AGENDA

PLANNING & ZONING COMMISSION REGULAR MEETING

TUESDAY, APRIL 6, 2021 - 3:30 PM

MCALLEN CITY HALL, 1300 HOUSTON AVENUE

SUBDIVISION NAME: ONLY LOVE HOME CARE	
REQUIREMENTS	
STREETS AND RIGHT-OF-WAYS	
Dove Ave.: 30 ft. dedication for 75 ft. from centerline for 150 ROW Paving: min. 65 ft. Curb & gutter: both sides **Show centerline and new property line after accounting for dedication	Required

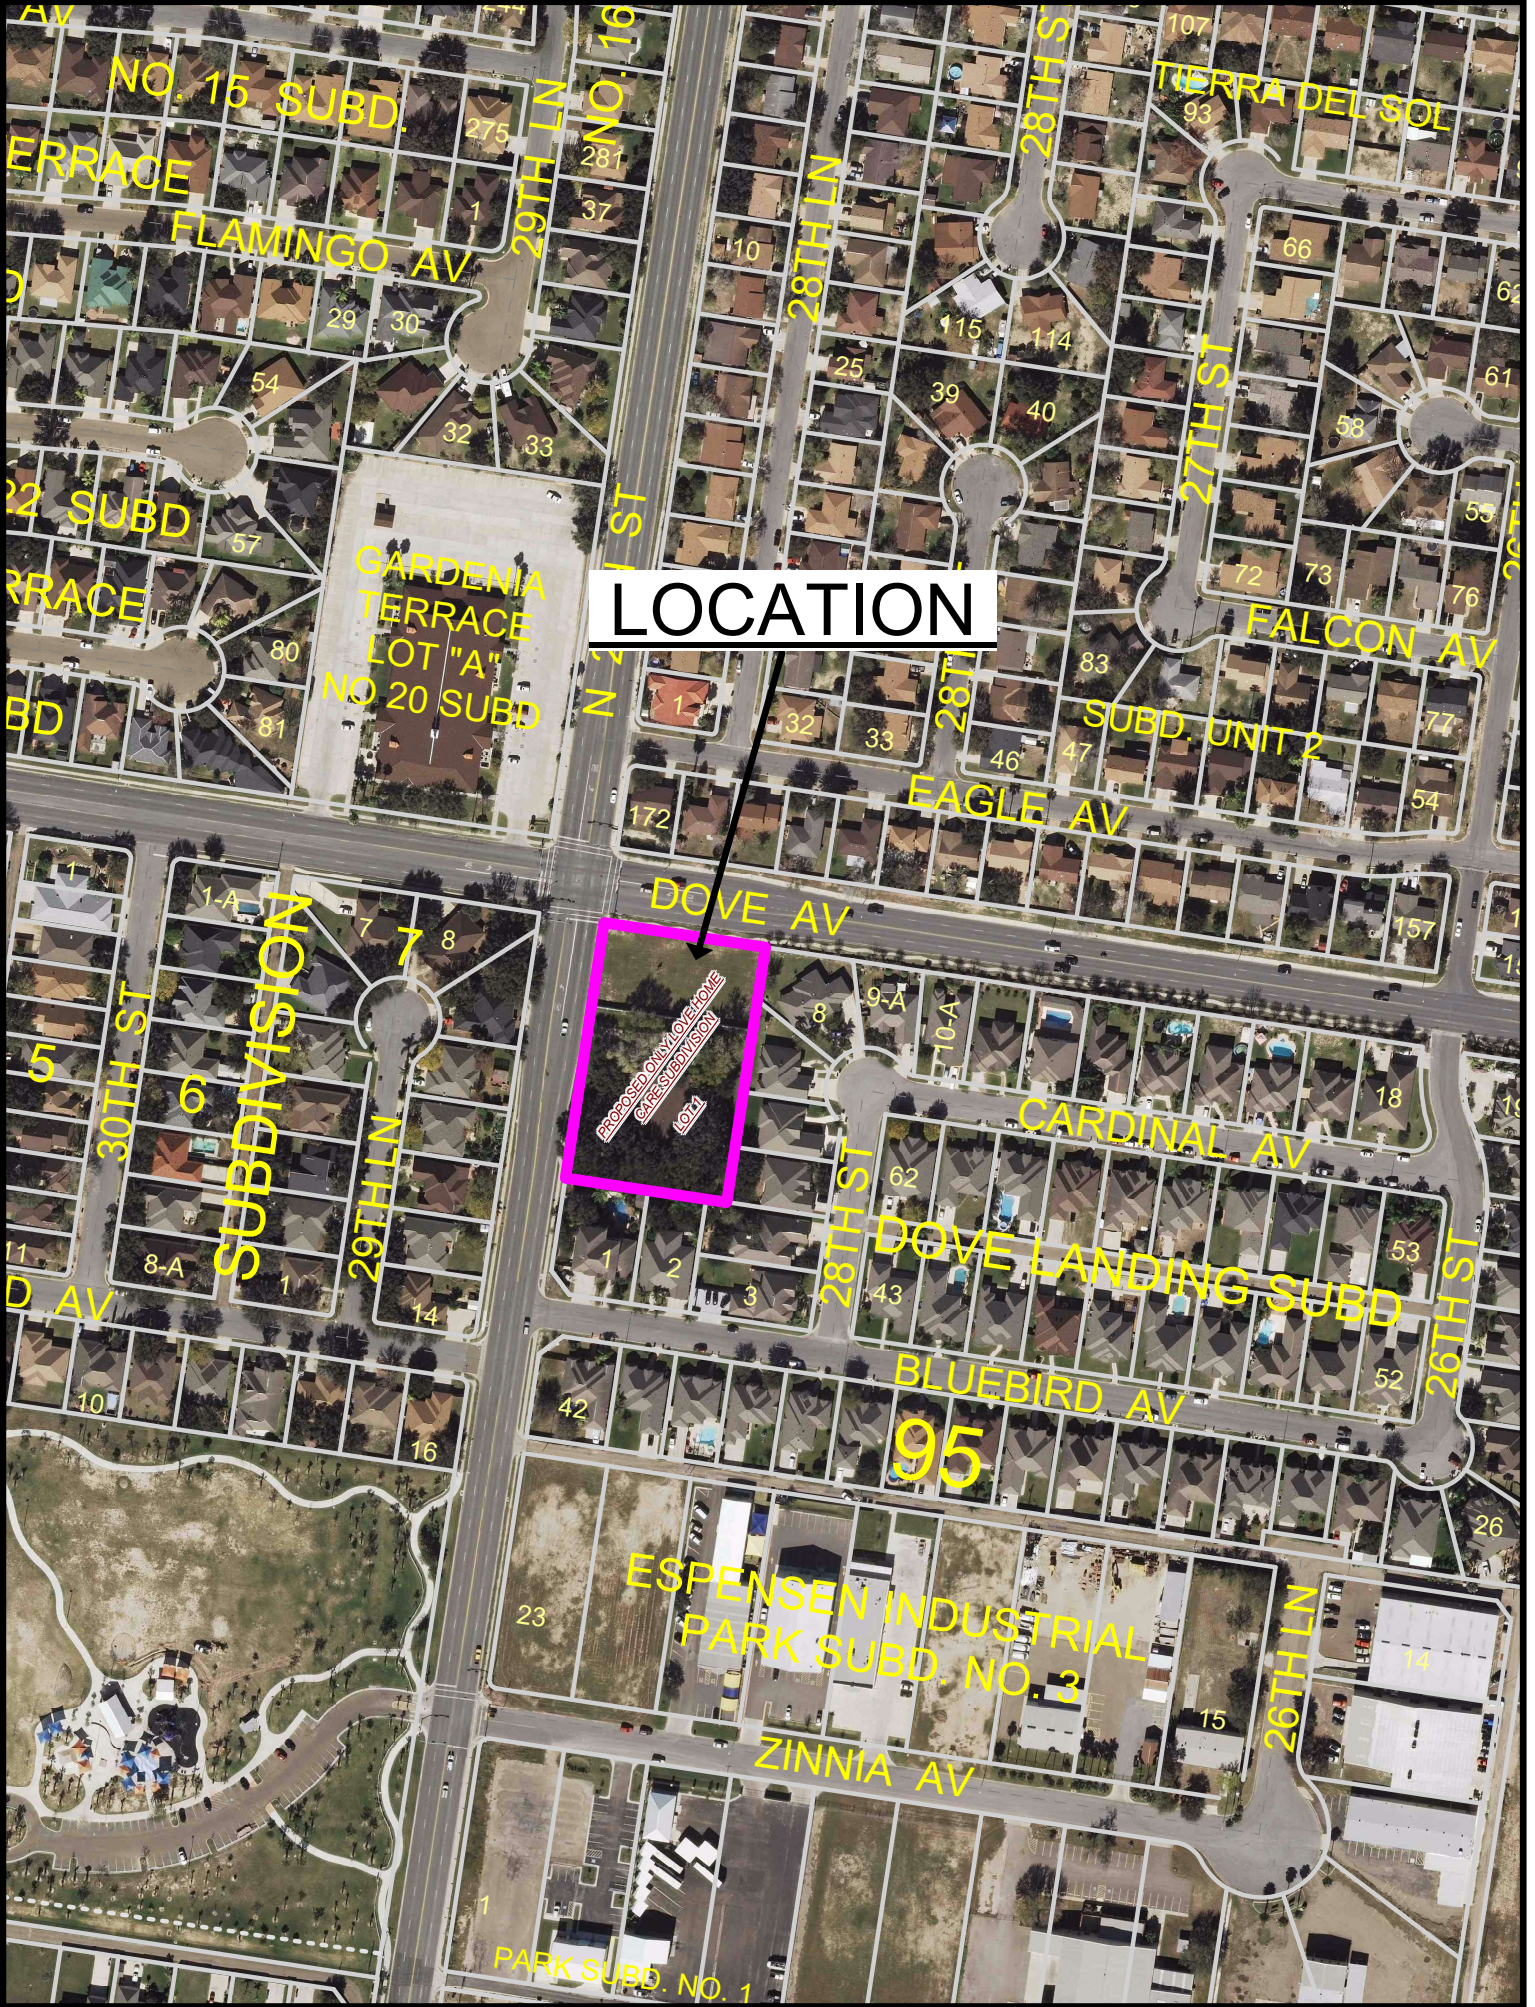
N. 29th Street: min. 10 ft. dedication for 50 ft. from centerline for 100 ft. ROW Paving: 65 ft. Curb & gutter: both sides **Show centerline and ROW to new property line after accounting for dedication	Required
Paving _____ Curb & gutter _____	Applied

* 800 ft. Block Length	NA
* 600 ft. Maximum Cul-de-Sac	Applied
ALLEYS	
ROW: 24 ft. Paving: 20 ft. *Plat submitted March 25, 2021 includes Note #13 indicating service drive will be provided during site plan review.	Applied
SETBACKS

* Front Dove Ave.: 75 ft. or greater for easements or approved site plan N. 29th Street: 50 ft. or greater for easements or approved site plan	Applied
* Rear: In accordance with the Zoning Ordinance, or greater for easement, or approved site plan	Applied

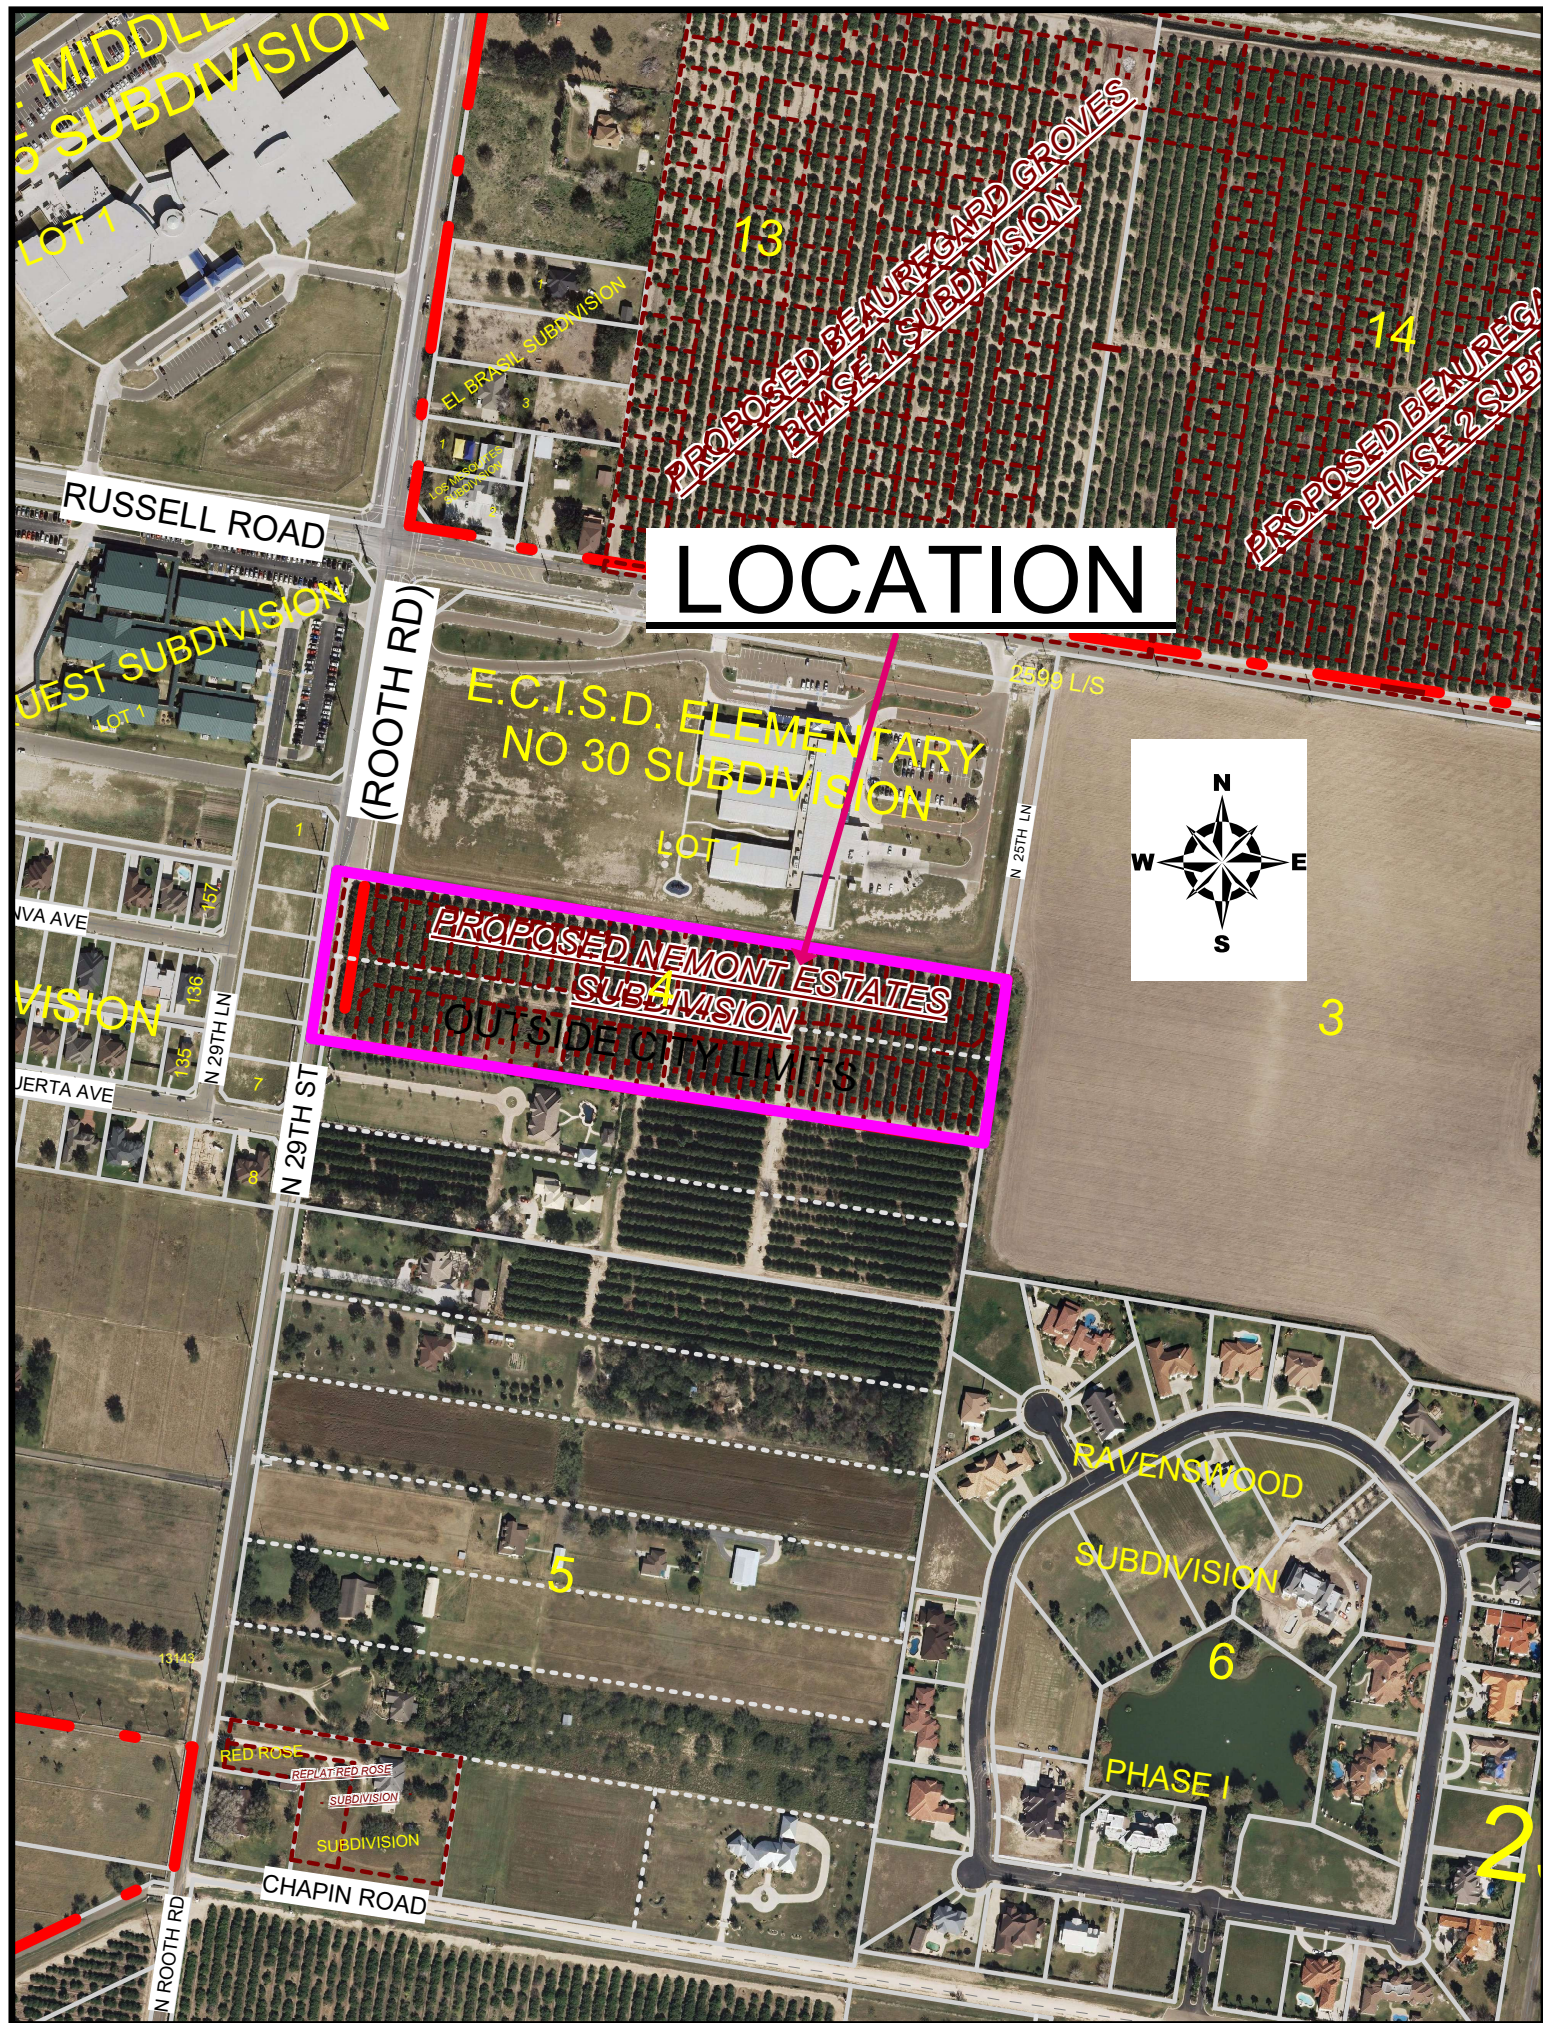
N. 29th Street (Rooth Road): 82.90 ft. ROW dedication for 100 ft. ROW
Paving: 65 ft. Curb & gutter: Both sides
**Must show centerline to determine if any ROW dedication is required prior to final.
**Please show ROW on both sides of centerline and total ROW after accounting for any ROW dedication required prior to recording.
****Please label the "19.08 ft." reference on the North 29th Rd. prior to recording.
**Monies must be escrowed if improvements are not built prior to recording.
**COM Thoroughfare Plan

North 25th Lane: 30 ft. dedication for 30 ft. from centerline for 60 ft. ROW
Paving: 40 ft. Curb & gutter: Both sides
**Monies must be escrowed if improvements are not built prior to recording.
***Please label the "30.00 ft." reference on North 25th Lane prior to recording.
****Label centerline to determine if any ROW dedication is required prior to recording.
*****Show ROW on both sides of centerline and total ROW after accounting for any ROW dedication needed prior to recording.
*****Subdivision Ordinance: Section 134-105

* Interior Sides: 6 ft. or greater for easements.
**Please revise plat note as shown above prior to recording
**Zoning Ordinance: Section 138-356

<ul style="list-style-type: none"> * Corner: 10 ft. or greater for easements. **Please add plat note as shown above prior to recording. **Zoning Ordinance: Section 138-356 * Garage: 18 ft. except where greater setback is required; greater setback applies. **Zoning Ordinance: Section 138-356 *ALL SETBACKS ARE SUBJECT TO INCREASE FOR EASEMENTS OR APPROVED SITE PLAN 	Applied
	Applied
	Applied
SIDEWALKS	
<ul style="list-style-type: none"> * 4 ft. wide minimum sidewalk required on east side of North 29th Street (Rooth Road), west side of North 25th Lane, and both sides of interior streets. **Please revise plat note as shown above. ****Subdivision Ordinance: Section 134-120 * Perimeter sidewalks must be built or money escrowed if not built at this time. 	Applied
	Applied
BUFFERS	
<ul style="list-style-type: none"> * 6 ft. opaque buffer required from adjacent/between multi-family residential and commercial, and industrial zones/uses and along North 29th Street and North 25th Lane. **Please revise plat note as shown above prior to recording **Landscaping Ordinance: Section 110-46 * 8 ft. masonry wall required between single family residential and commercial, industrial, or multi-family residential zones/uses. **Landscaping Ordinance: Section 110-46 *Perimeter buffers must be built at time of Subdivision Improvements. 	Applied

16
PROPOSED BH INDUSTRIAL DRIVE SUBDIVISION

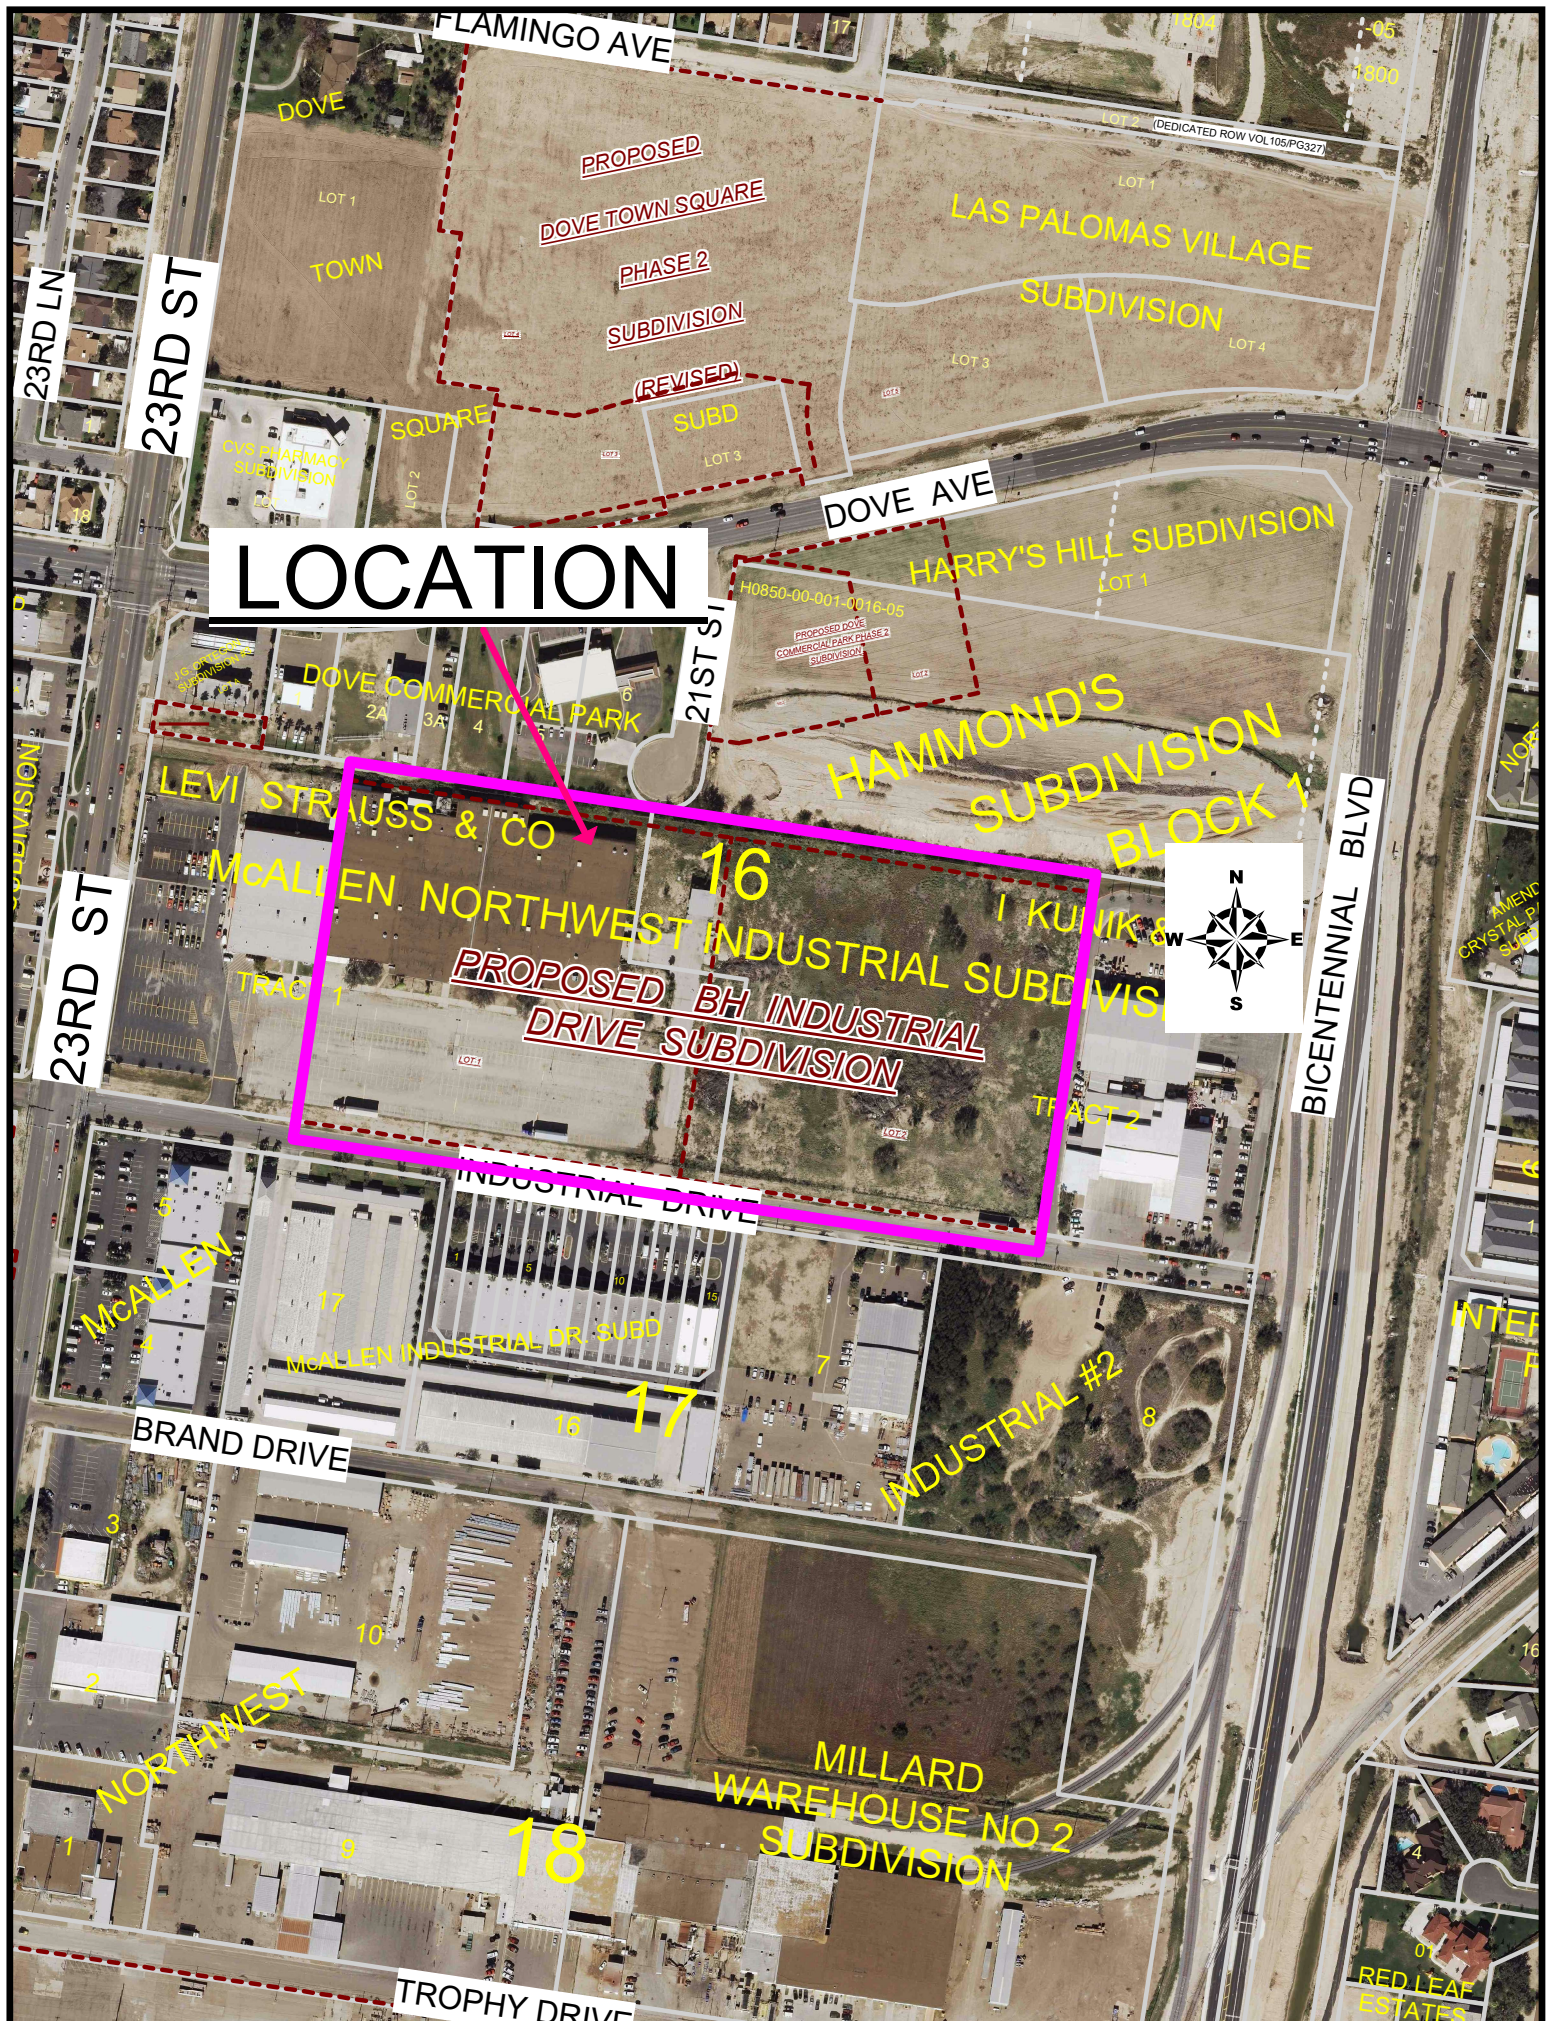
Industrial Drive: 30 ft. from centerline for 60 ft. ROW
Paving: 40 ft. required Curb & gutter: Both sides
**Engineer to clarify paving width prior to final to verify if any additional paving is required.
***Include document number where ROW was dedicated prior to final or indicate if Industrial Drive ROW is being dedicated by this plat prior to final.
*****Subdivision Ordinance: Section 134-105

ROW: 20 ft. Paving: 16 ft.
*Alley required for commercial properties.
**Engineer must clarify if trash pick up services are proposed to be from the north property prior to final to determine requirements.
***Label ROW accordingly on the north side of the property for the 30 ft. strip prior to final. IF ROW has been abandoned, please show document number prior to final.
**Subdivision Ordinance: Section 134-106

* Perimeter sidewalks must be built or money escrowed if not built at this time.	Applied
BUFFERS	
* 6 ft. opaque buffer required from adjacent/between multi-family residential and commercial, and industrial zones/uses. **Plat note must be added prior to final. **Landscaping Ordinance: Section 110-46	Non-compliance

* 8 ft. masonry wall required between single family residential and commercial, industrial, or multi-family residential zones/uses. **Plat note must be added prior to final. **Landscaping Ordinance: Section 110-46	Non-compliance
*Perimeter buffers must be built at time of Subdivision Improvements.	Applied
NOTES

* Existing: I-1 Proposed: I-1 **Engineer must indicate proposed use to verify if a rezoning will be required prior to final. **Zoning Ordinance: Article V	Applied
